## 1 产品介绍

1	产品编号	Plastic mould 12035.03 (M2-2)
2	产品名称	12035. 03
3	数据版本	V1
4	产品大小(mm)	31X12X114
5	产品壁厚(mm)	
6	产品材料	LDPE-30%/寒冷剂+发紫外线剂+ 色 料-8%/POLYPROPYLENE-62%
7	产品收缩率(%)	
8	产品表面处理	抛光

**P.L 确认**

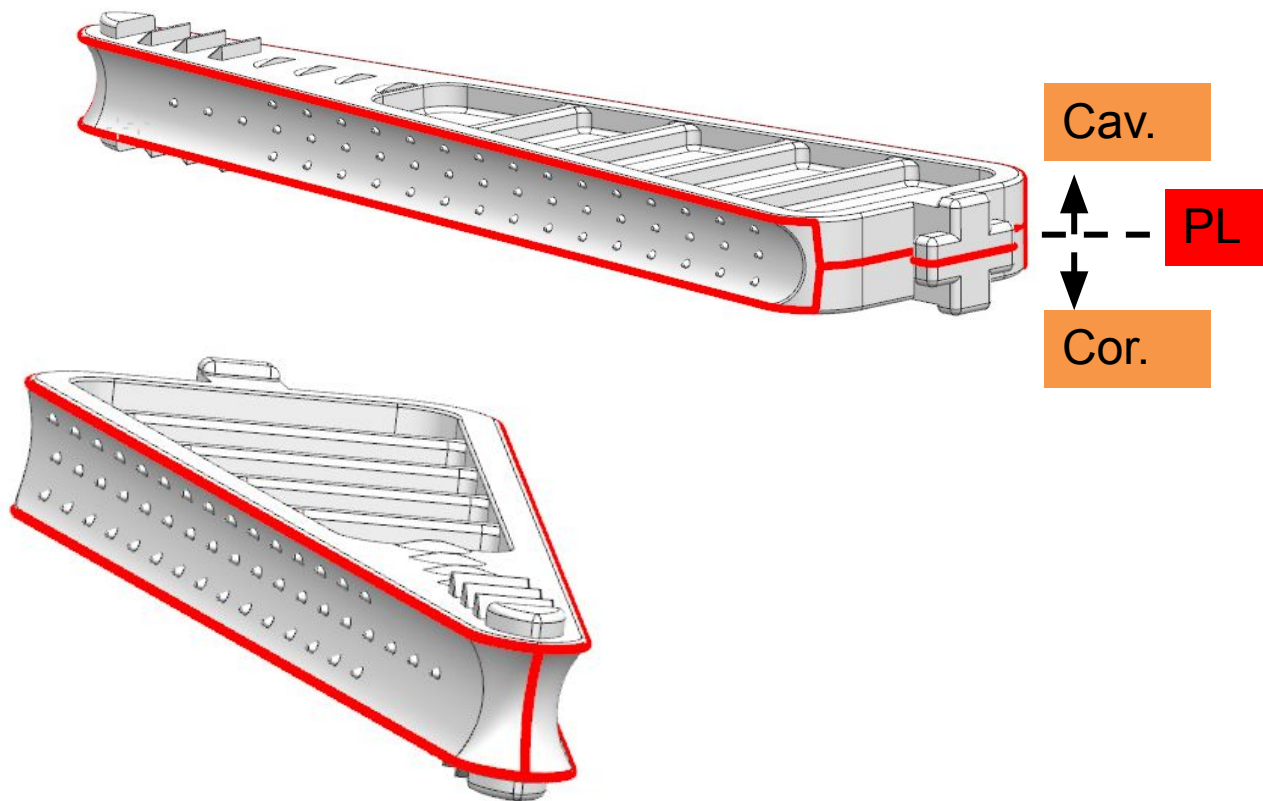
红色线为产品分型线, 请确认。  
The red line is parting line, please check it.

## 3 脱模角度分析

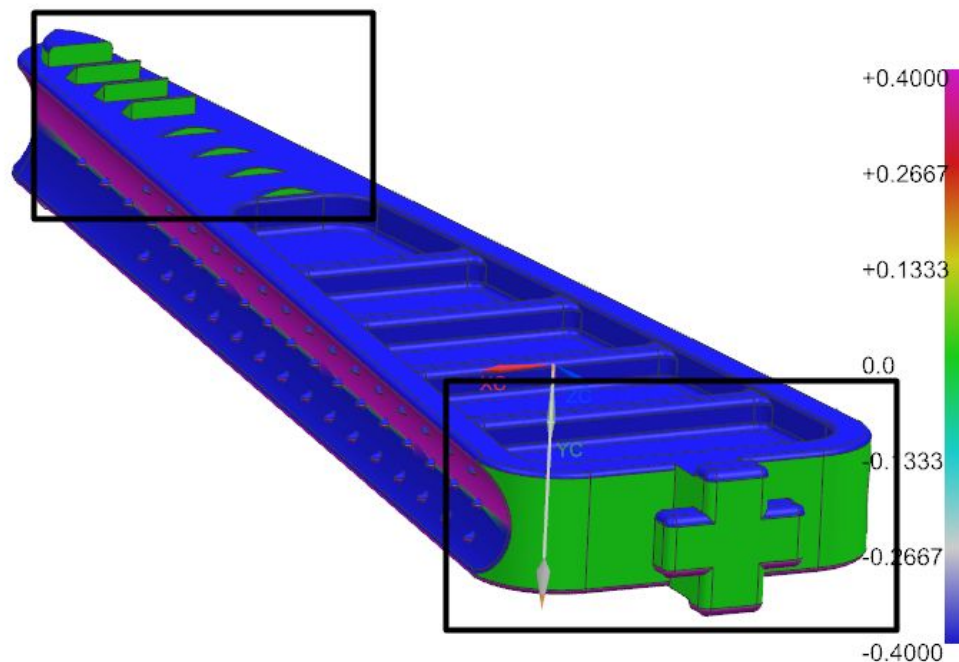
型芯型腔黑框位置 绿色面均无斜度  
 确认能否增加0.5°脱模斜度。(修改处涉及装配面)  
 There are no draft angle at black frame area both for core and cavity side). Please check whether we can add 0.5°draft angle.(The modify area will influence assembly).

## 4 壁厚分析

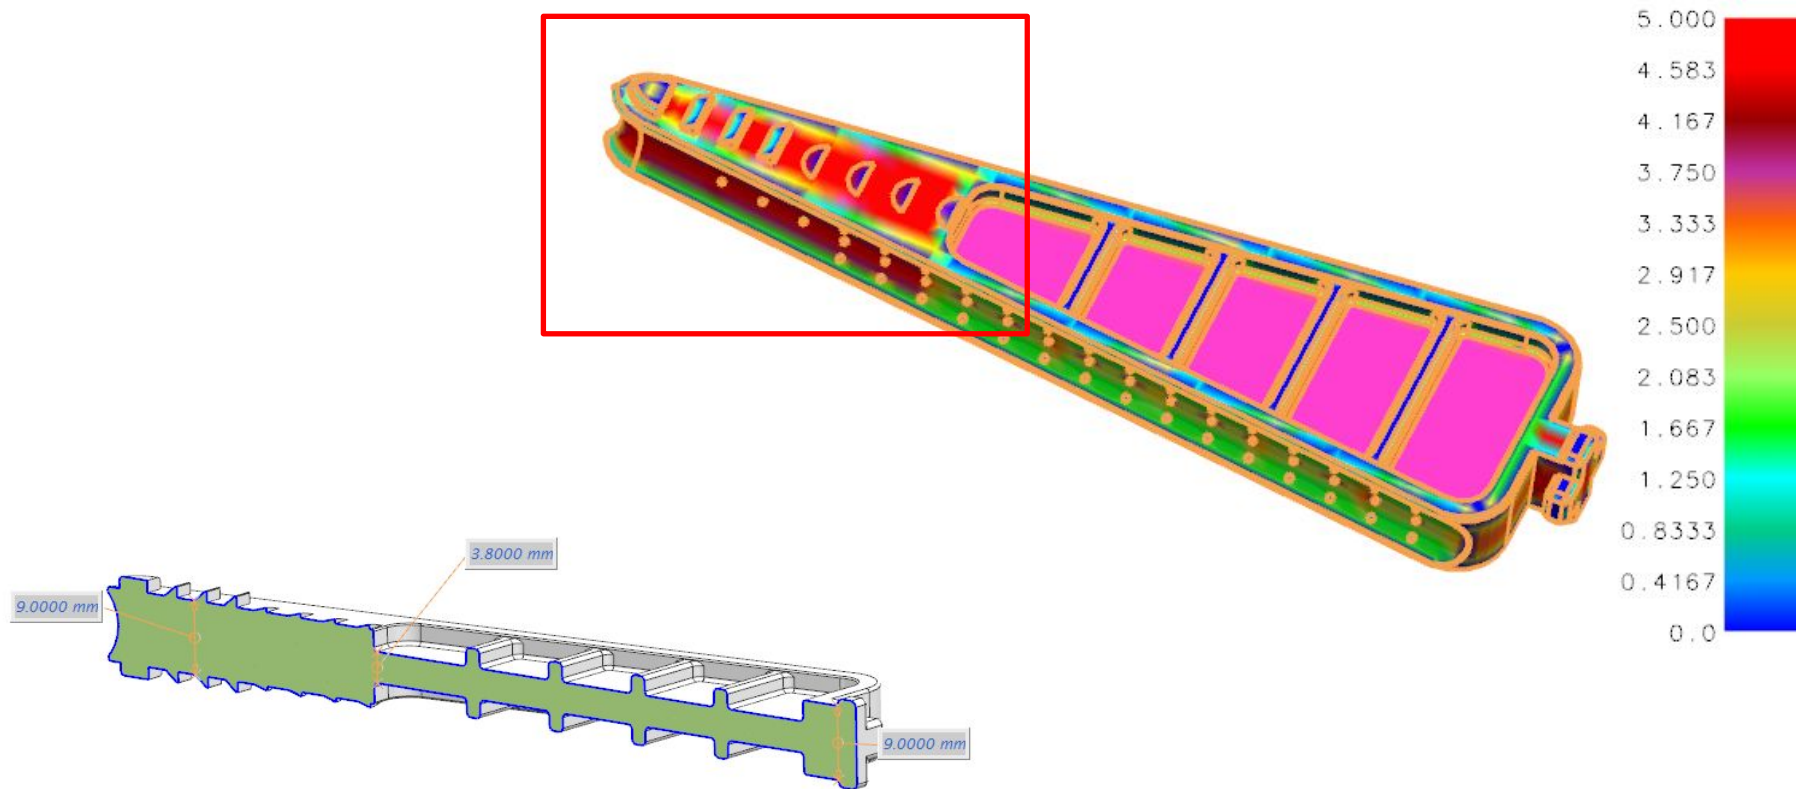
产品壁厚如图分布。

The thickness of product is shown as picture.

## 5 缩痕分析

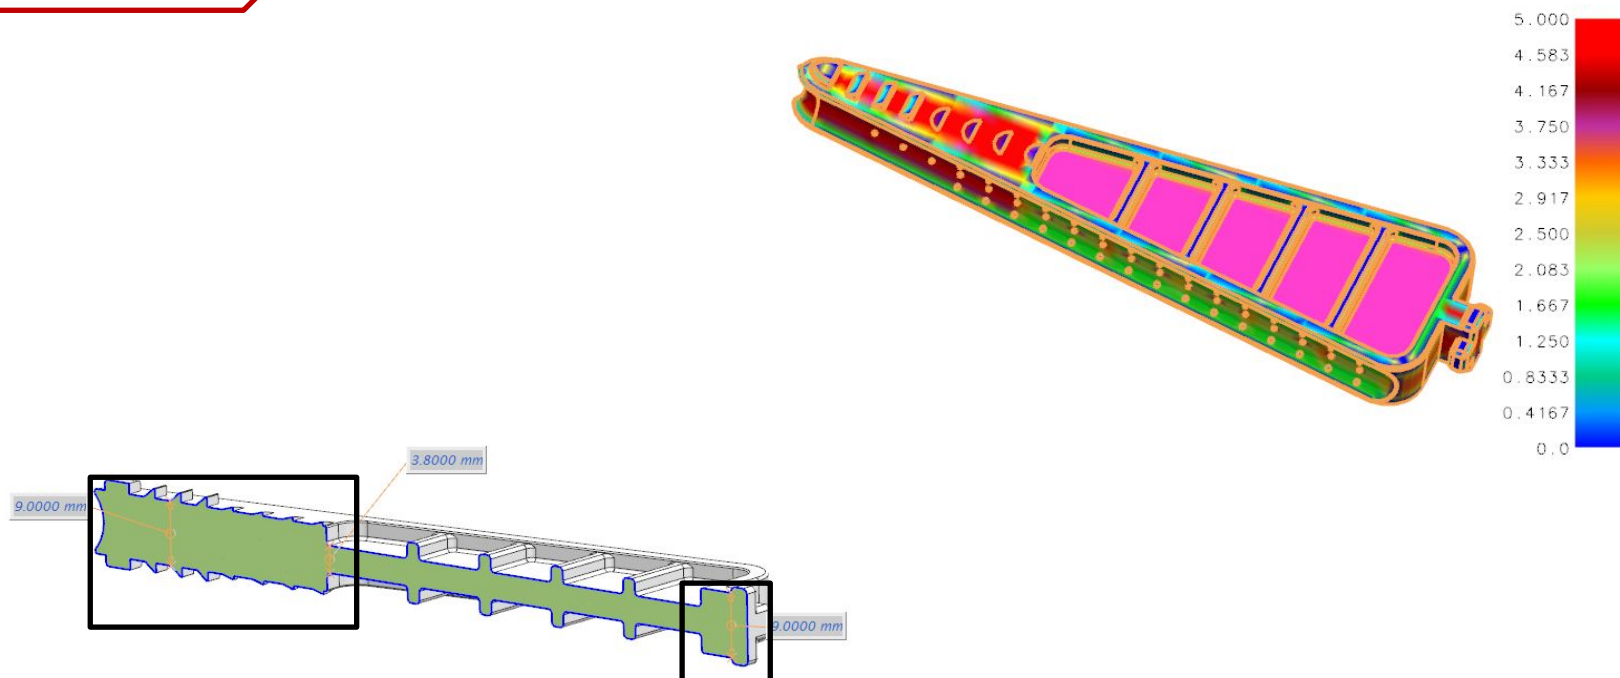
产品壁厚引起的缩痕, 确认是否可接受。

There will have sink mark due to thick thickness, please check whether it is acceptance.

## 6 产品与图纸对比

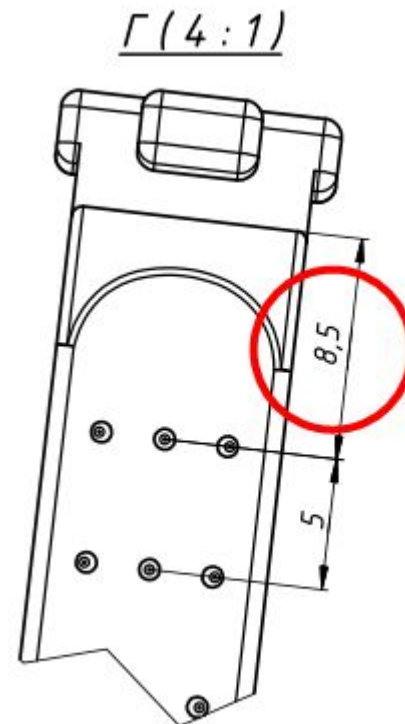
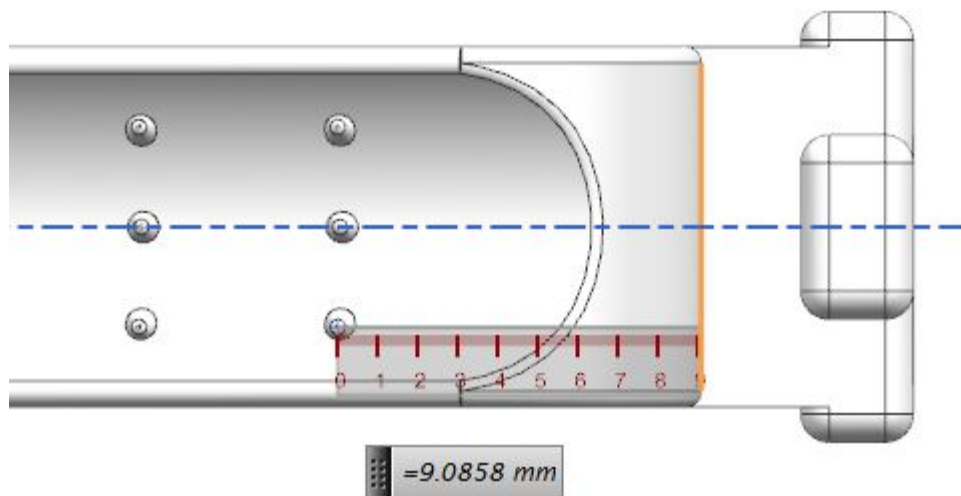
产品与图纸对比存在误差, 请确认

There are difference between 3D data and 2D drawing. Please check which one is correct.

## 7 产品与图纸对比

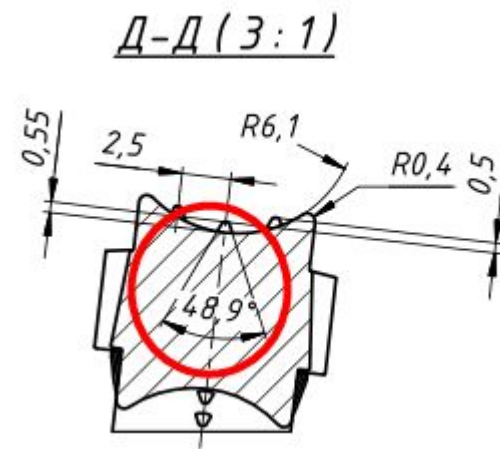
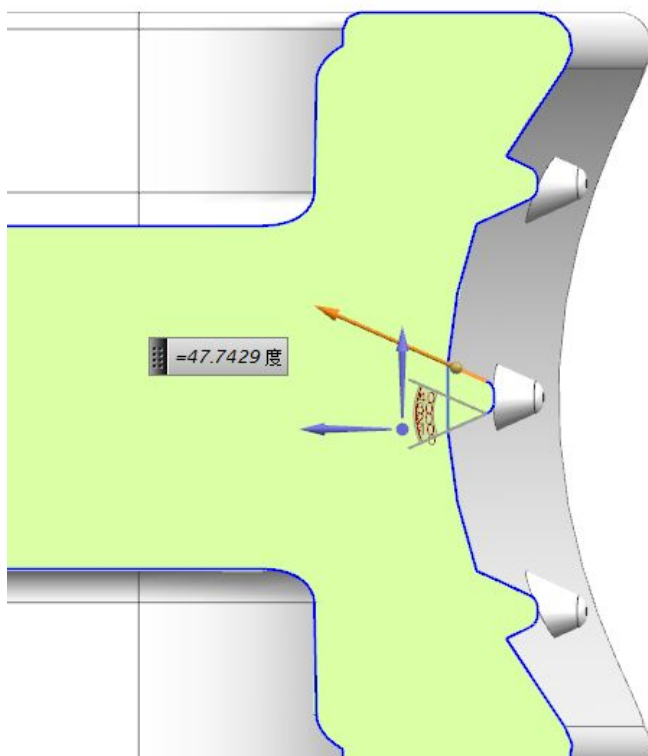
产品与图纸对比存在误差, 请确认  
There are difference between 3D data and 2D drawing.  
Please check which one is correct.
